THE STANDARD AT SEATTLE - THE TOWERS

RECOMMENDATION MEETING #2

DPD PROJECT #: 3033094

SUBMITTAL DATE: AUGUST 14, 2020

CURRENT - TOWER CONCEPT

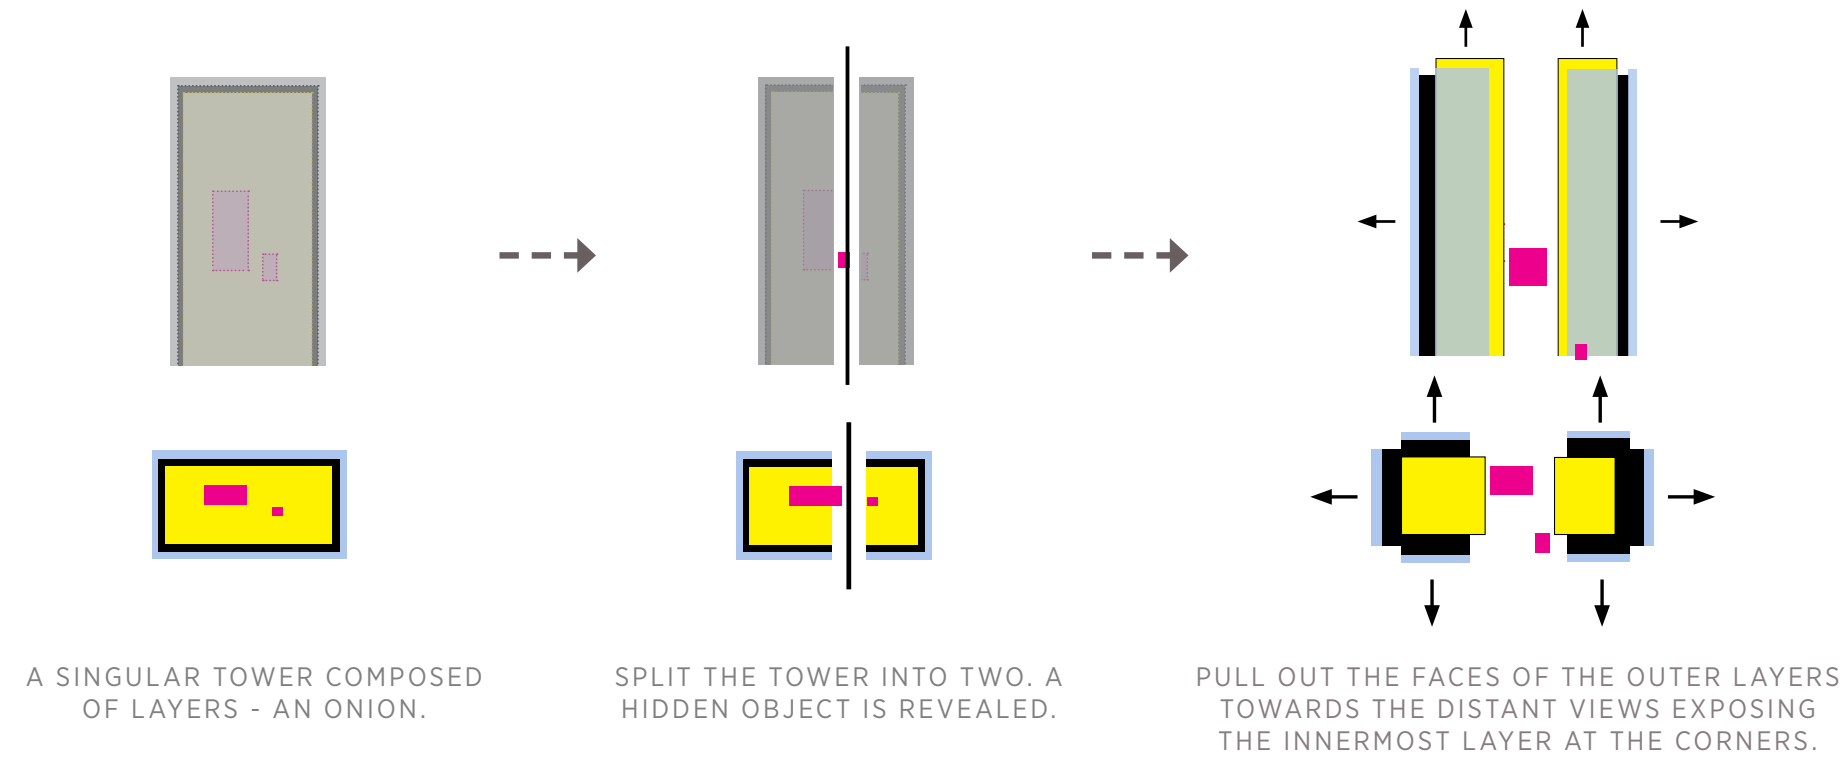
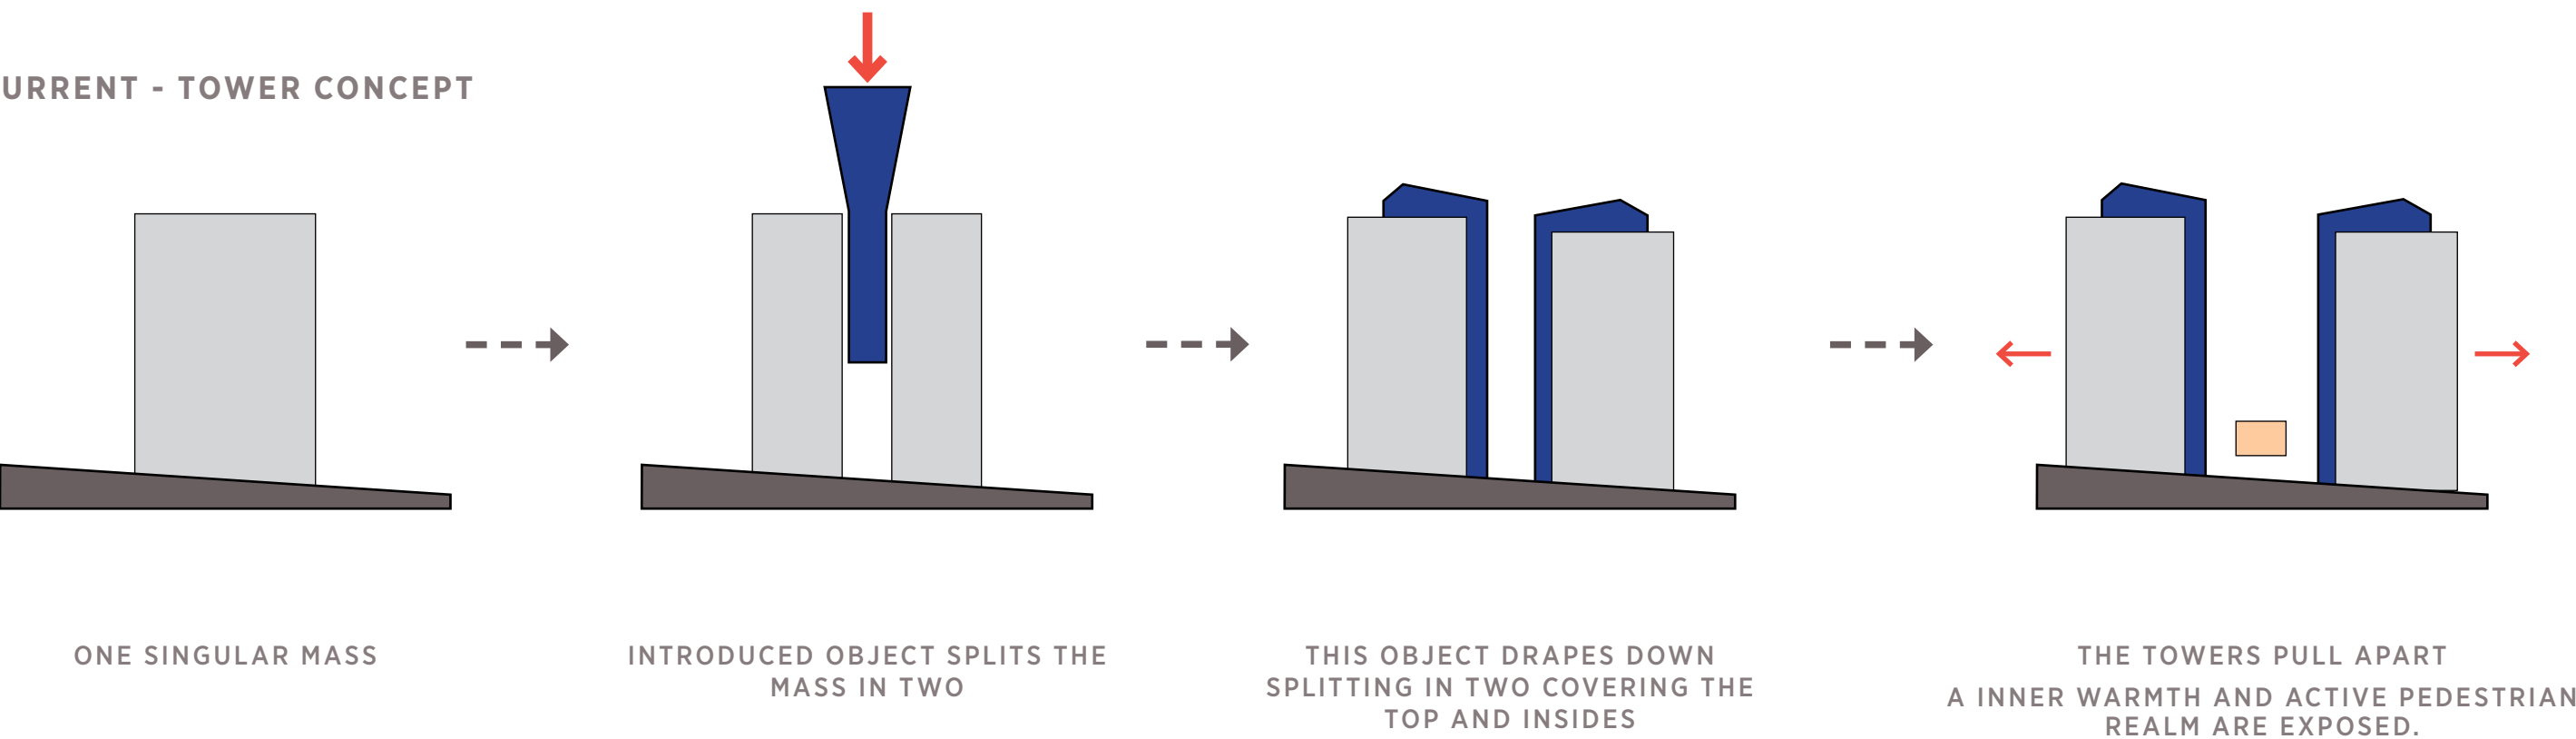
AREAS OF CONCERN:
OVERALL DESIGN CONCEPT, THE MUSCLE MATERIAL, AND THE JEWEL

THE MUSCLE MATERIAL FROM SKY TO GROUND.
THE JEWEL EXPRESSION.

MUSCLE MATERIAL A POWERFUL VERTICAL ELEMENT COMING TO THE GROUND IN A STRONG, WELL RESOLVED WAY CONSISTENT ACROSS THE PROJECT.

The strong sculptural element which, through its simple form and complex textural quality, visually ties together the two towers. The muscle material comes all the way to the ground creating “book ends” on either side of the mid-block corridor and become signature in that no other material in the project goes from sky to ground.

CURRENT - MID-BLOCK ENTRY

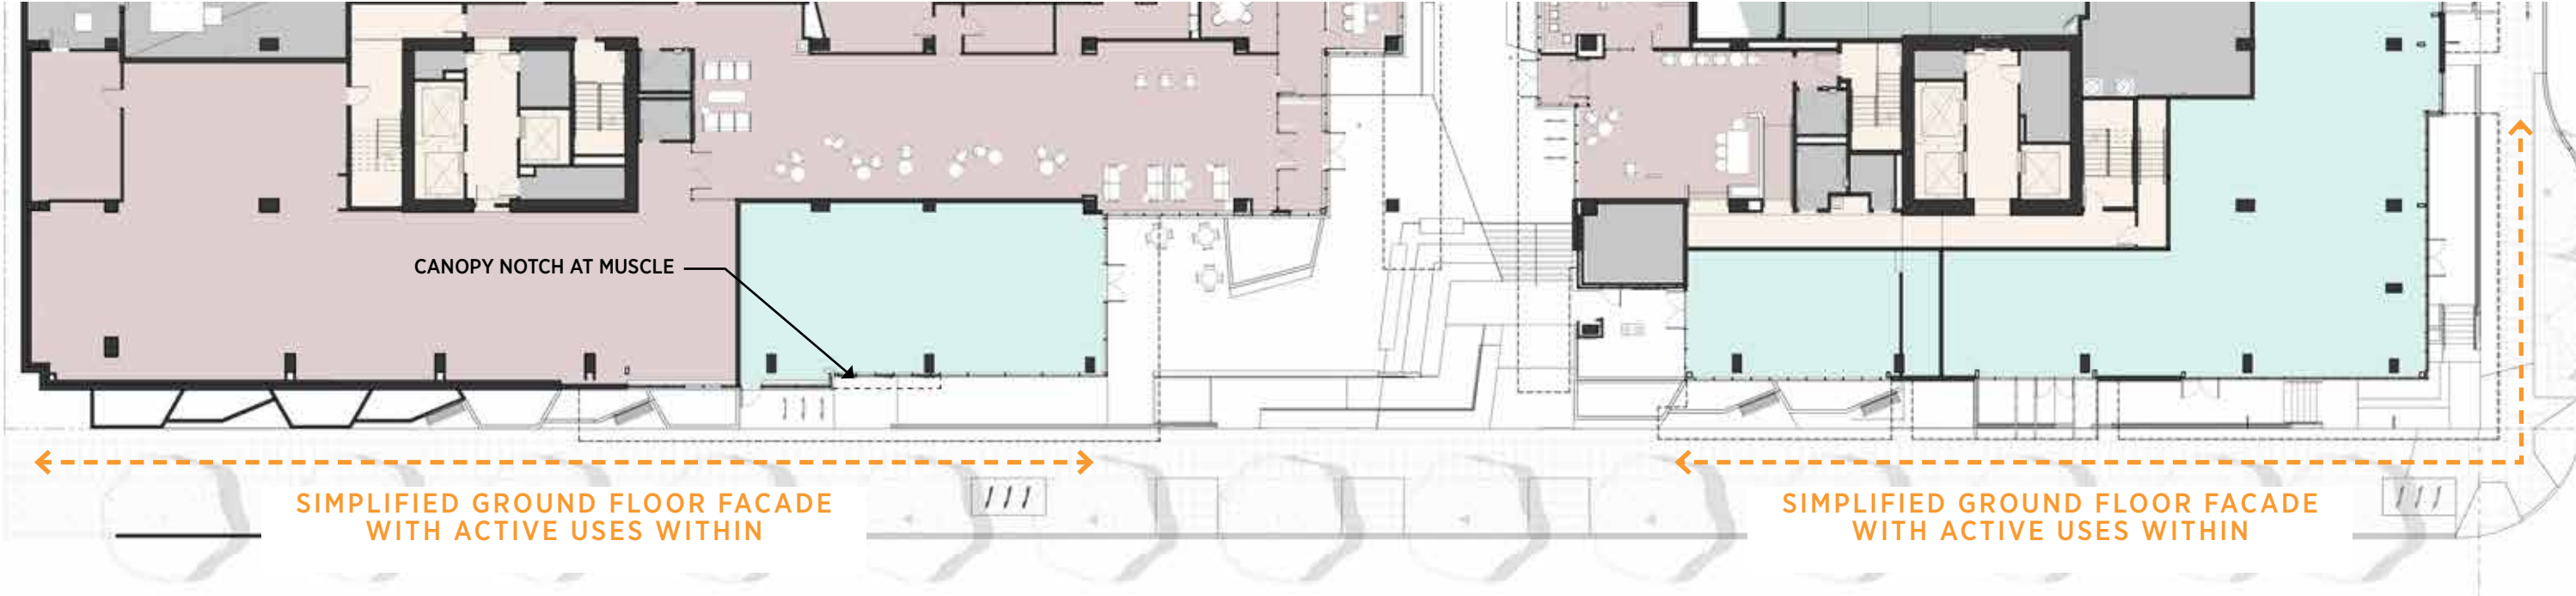
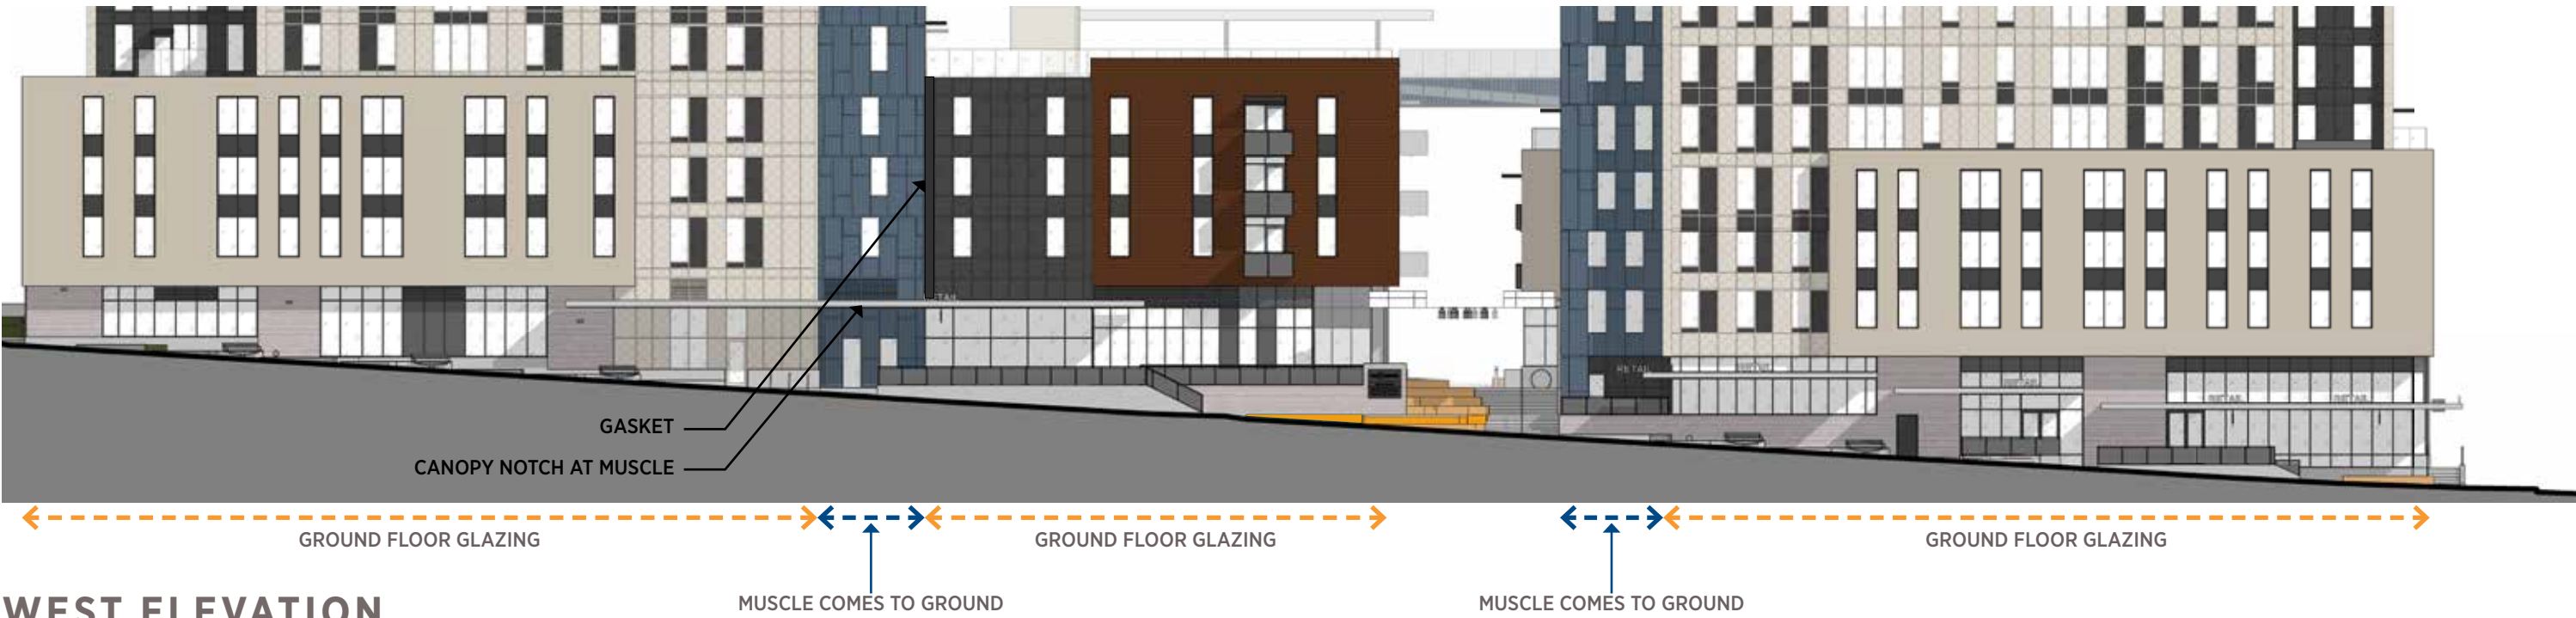
THE MANNER IN WHICH THE BLUE ‘MUSCLE’ MATERIAL COMES TO GROUND SHOULD BE STRONG AND WELL RESOLVED AND APPLIED CONSISTENTLY ACROSS THE PROJECT

The blue muscle material comes to the ground on both sides of the mid-block entry. A 1' wide x 1' deep gasket separates the blue muscle material from the dark spandrel on the north podium. Canopies at the muscle material have been notched to allow the material to continue without interruption to the ground.

THE JEWEL POSSIBILITIES - OPEN SPACE BETWEEN BUILDINGS, RESPONSE TO LANDSCAPE, OR ACTIVITY GENERATING SPACE?

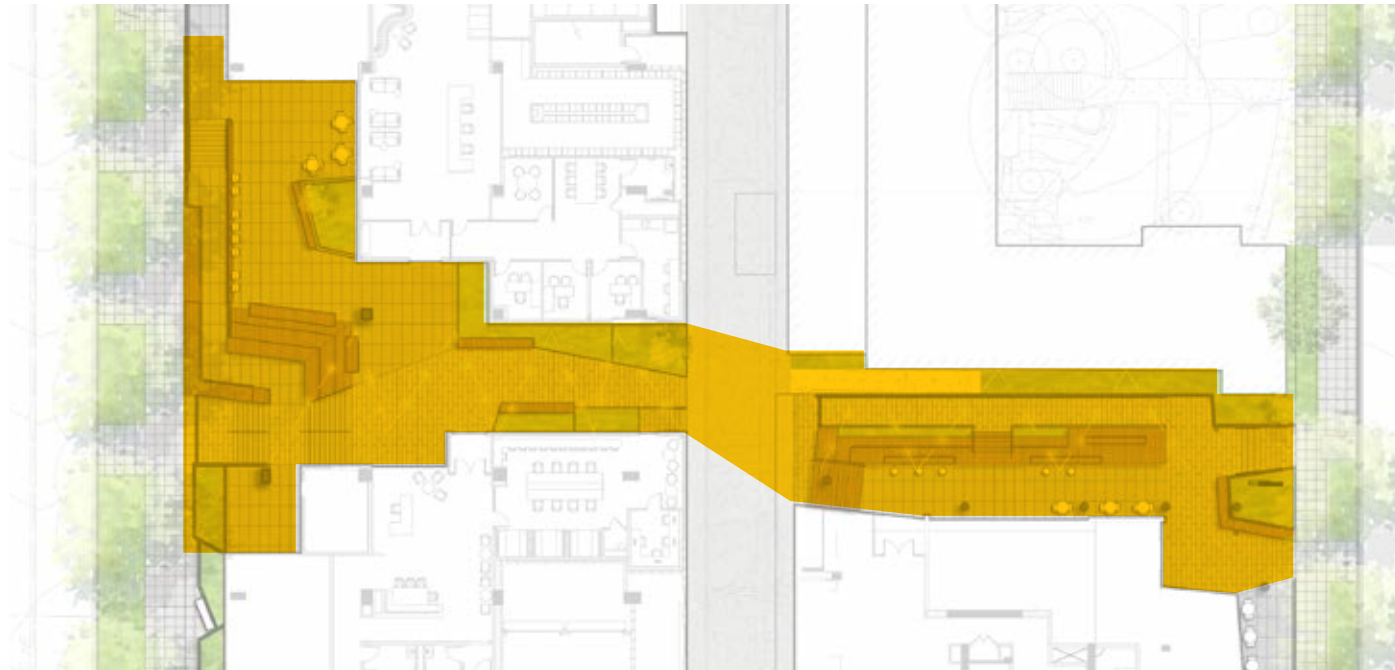
The EDG-02 Jewel was an object that had no other purpose other than it strived to be different. It had no connection to the overall design. And, it was inherently flawed in that this revealed object was not what was special within the project.

The DRB1 Jewel was a space. By going to the extreme of what the revealed “object” could be, the DRB1 solution did not have enough presence to draw pedestrians in.

The Jewel of this project is a combination of active, public mid-block corridor with a warm, inviting object. The open space will most impact the pedestrian experience and the neighborhood. Balconies have been introduced at the podium level facing into the mid-block corridor to continue the visual conversation between the north and south tower up high.

CURRENT - SECTION THROUGH MID-BLOCK CORRIDOR LOOKING SOUTH

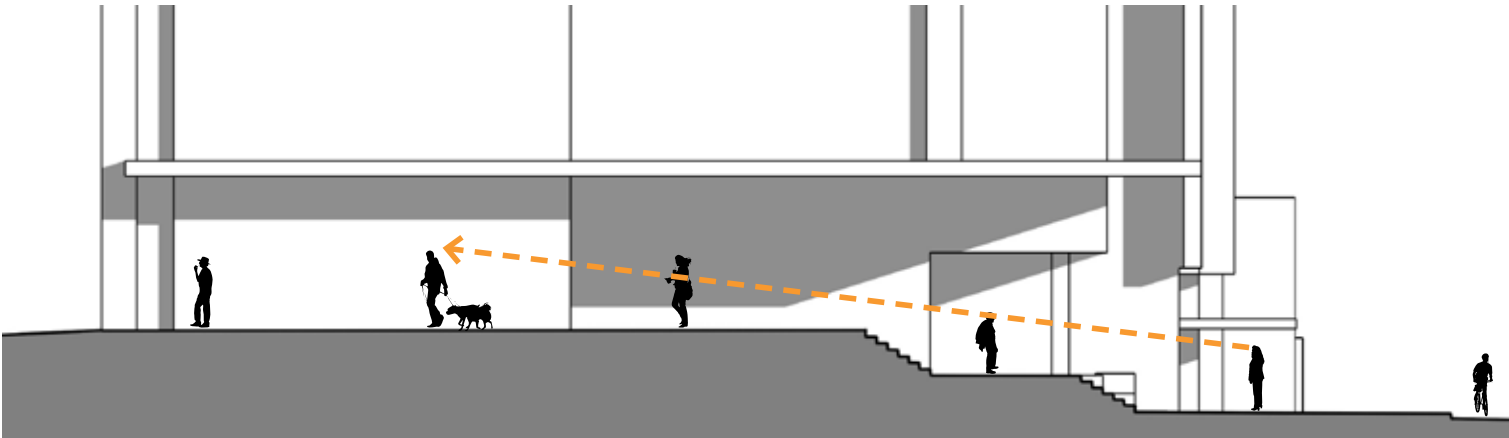
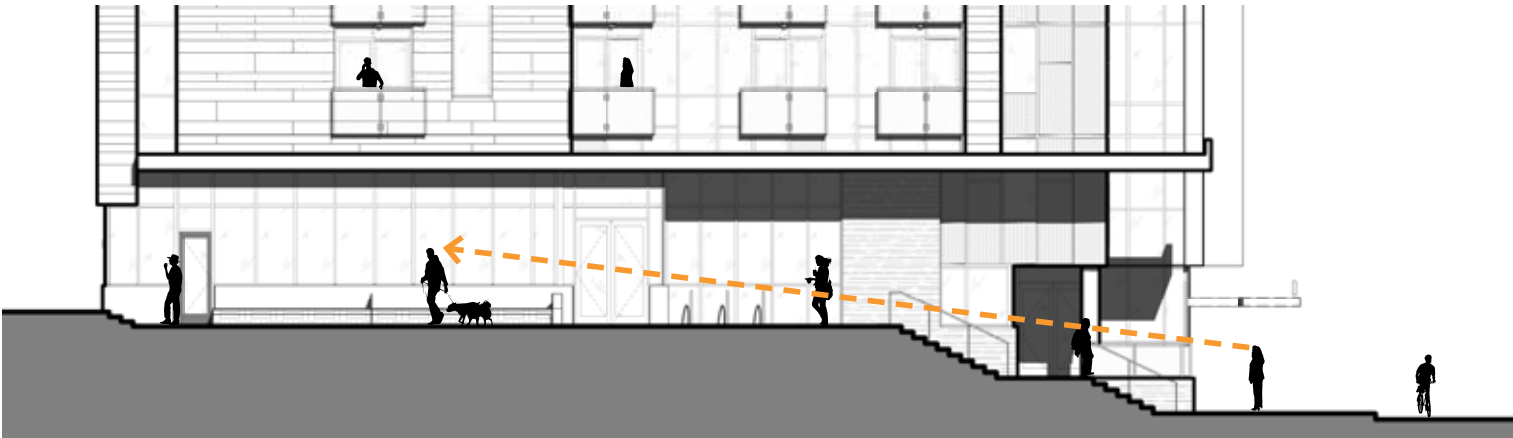
MINIMIZE GROUND CHANGE THROUGH THE MIDBLOCK CONNECTION

By rotating the north entry stair, and removing the stepping at the south retail outdoor area, the project is able to capitalize on larger single grade areas facing the 12th Avenue sidewalk. The walkway leading to the alley intersection slopes to eliminate the need for steps at the alley. The main stairs have been elongated to allow for better sitelines into the mid-block corridor.

CURRENT - VIEW THROUGH MID-BLOCK PLAZA

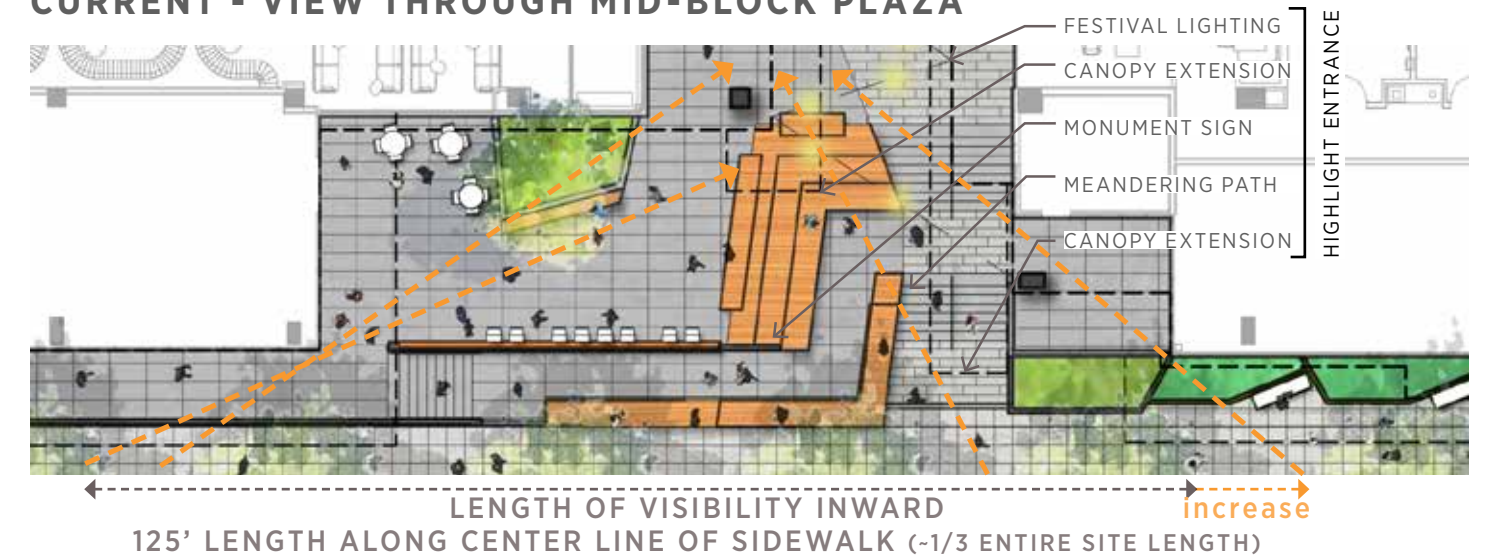
CREATE **SIGHTLINES** INTO THE MIDBLOCK CONNECTION

The planter on the mid-block plaza has been pushed up against the building to allow for more usable area for seating, and to open up the view through the space into the mid-block corridor. The raking of the stadium seating opens up the view and allows for a gradual transition up into the mid-block corridor. The south retail overlook is wider along the sidewalk to increase visibility into the mid-block. Multiple devices are used to draw attention to the mid-block opening.
